Six Chuter International LLC

SERVICE BULLETIN

Tuesday, June 12, 2012 SB-LEGEND 2012-01

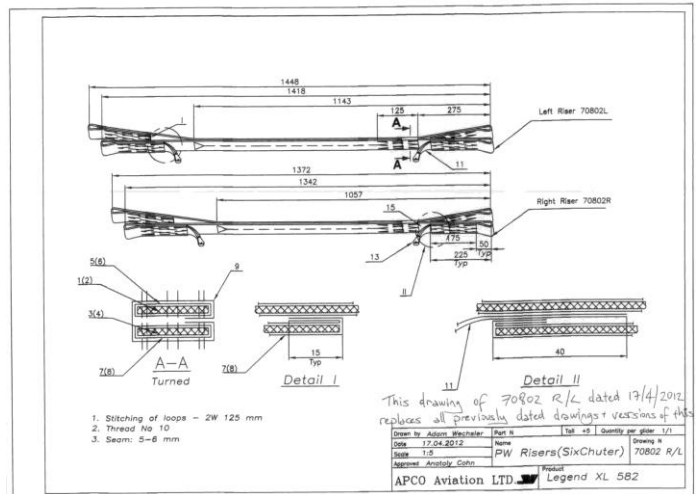
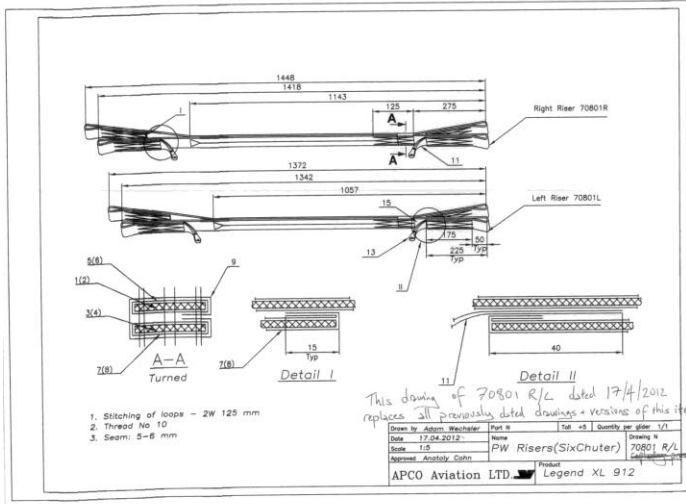
The previous standard canopy risers used on Six Chuter Legend's with the variable adjuster have been "High Energy" brand. This company is no longer producing those risers. We have now switched to the vendor "Apco" for the standard risers. These risers are specifically designed and produced by Apco for the Legend XL either with Rotax 582 or Rotax 912, flying either with the Apco Mark IV series wing or with the Performance Design Sunriser wings. These risers have been flight tested on both models and provide correction for torque with no additional rapid links required. The rear riser is also one inch higher that helps prevent "lock out" of canopy during the "kiting" (inflation) for takeoff phase.

- 3.1)3. The longer set of risers installs on the left outrigger when installing 70802 for Rotax 582. The longer set of risers installs on the right outrigger when installing 70801 for Rotax 912.

- 3.1)4. The lower end of the risers that attach to the c.g. adjuster is the end with the risers at even length. The top of each riser set is the one with the rear riser that is about one inch longer than the front riser.

- 3.1)5. The risers are attached to the c.g. adjusters with the longer rear riser at the top and to the rear and with the pulleys oriented on the front of the riser set.
